APPLICATION FOR APPROVAL TO USE AN EXISTING ON-SITE WASTEWATER TREATMENT & DISPOSAL SYSTEM
MECKLENBURG COUNTY - GROUNDWATER & WASTEWATER SERVICES
700 N. Tryon St., Suite 211 Charlotte, NC 28202
Phone: (704) 336-5103 Fax: (704) 336-6894

PLOT PLAN FOR PERMIT APPLICATION
ONE/TWO FAMILY, MODULAR, MOBILE HOME OR ZONING USE

SOIL/SITE EVALUATION
for ON-SITE WASTEWATER SYSTEM

Permit Number: 4835B

- PLOT PLAN -

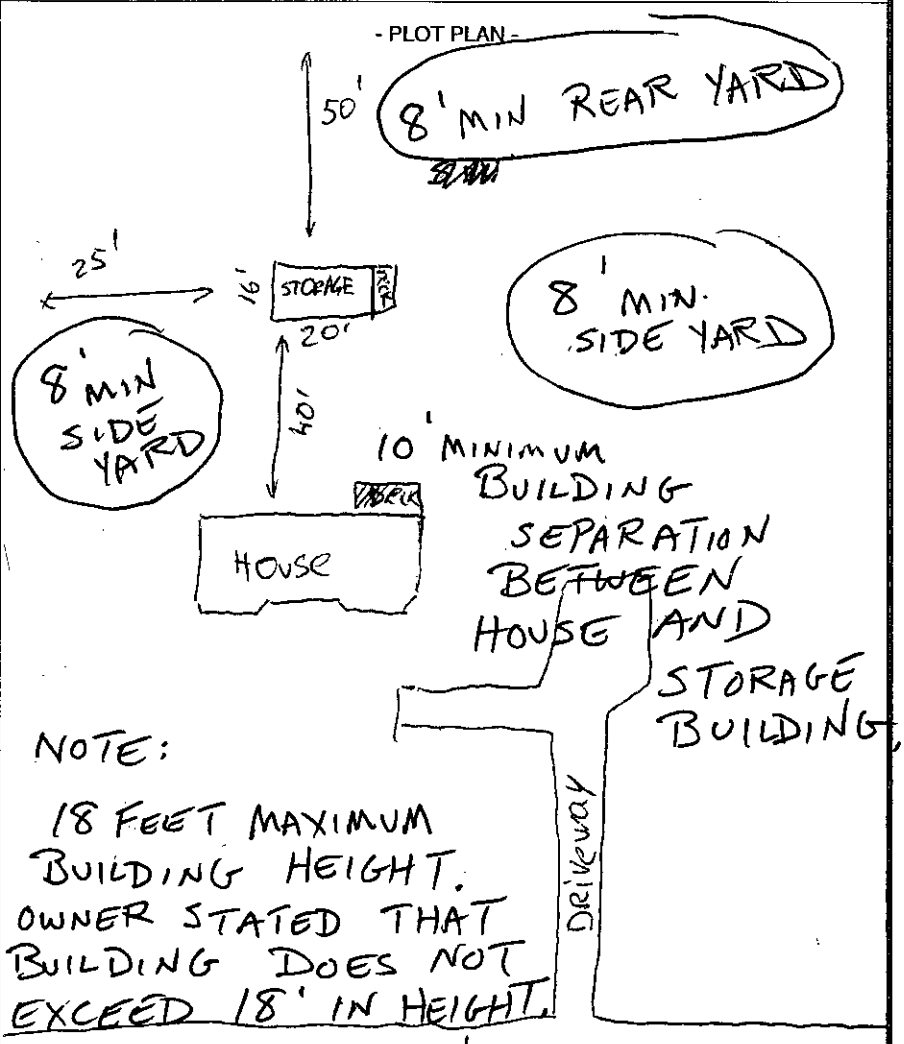
Comments: Detached Garage with two stories already built at time of inspection on 01-22-2010. One room had a closet framed. Wall was taken out and verified on 01-25-2010. Rooms are for office and storage only. Closet framing was removed.

Structure meets required setbacks off septic system.

PROPOSED PLOT PLAN

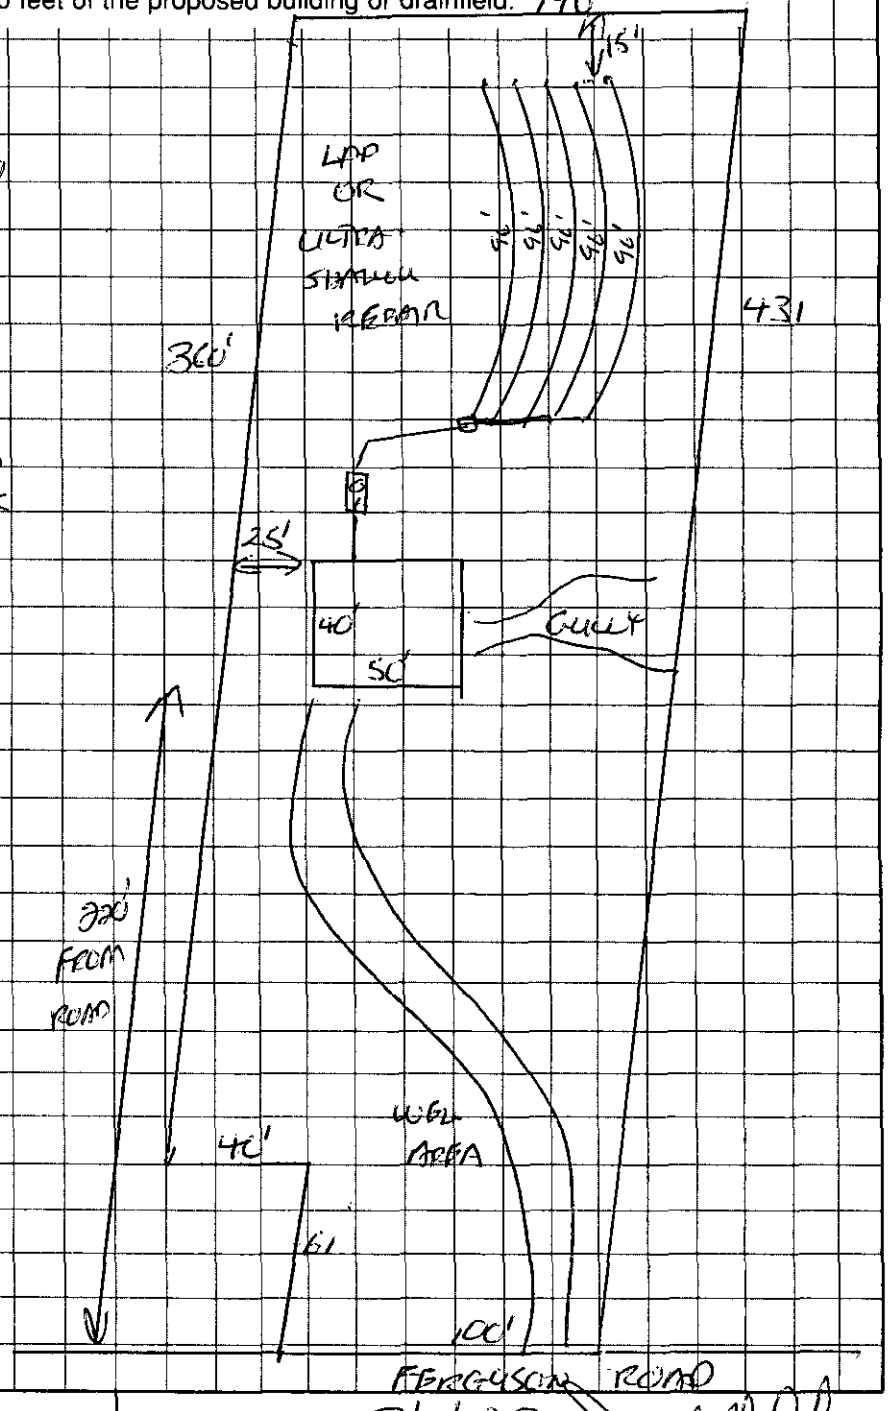
COMMENTS 100% Repair, recommend that proposed drainfield lines be staked off and area spot-bored due to soil variability

(1) INSTALL DRAINLINES SHALLOW (20") AND ON CONTOUR.

(2) INSTALL 6" SOIL CAP OVER DRAINFIELD

(3) LOCATE ALL WELLS 100 FROM ALL PARTS OF SEPTIC TANK SYSTEM.

(4) AREA FOR DRAINFIELD IS FLAGGED W/ PINK RIBBONS

PLOT OF SYSTEM

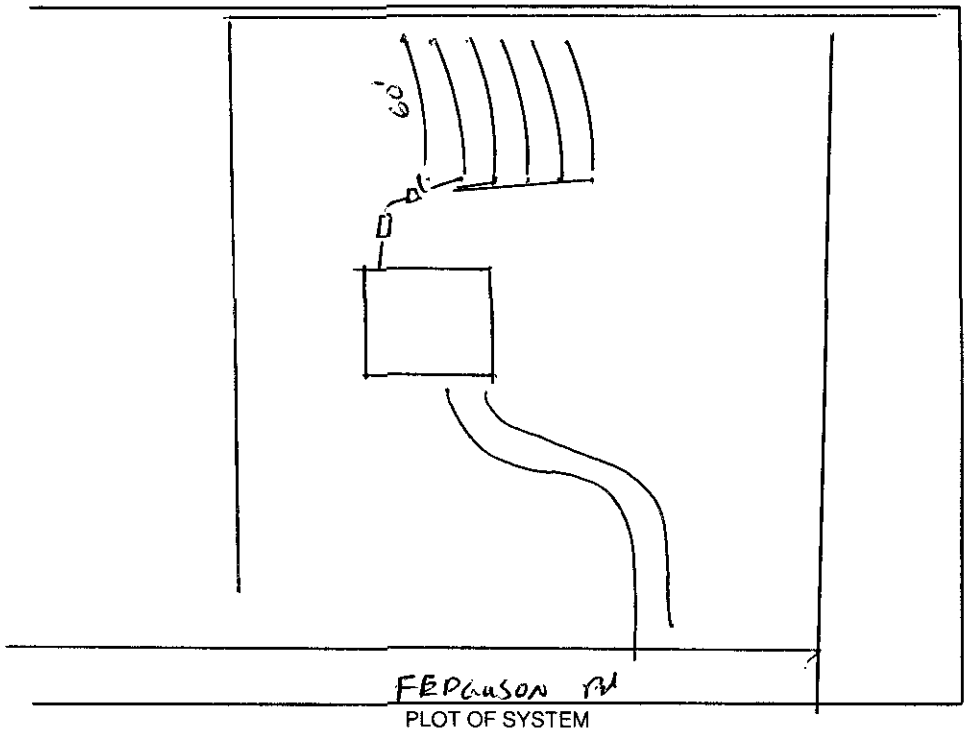
Comments: (1) OWNER REQUESTS TO MOVE HOUSE BACK, THEREFORE, TYPE III-G INNOVATIVE WILL BE REQUIRED.
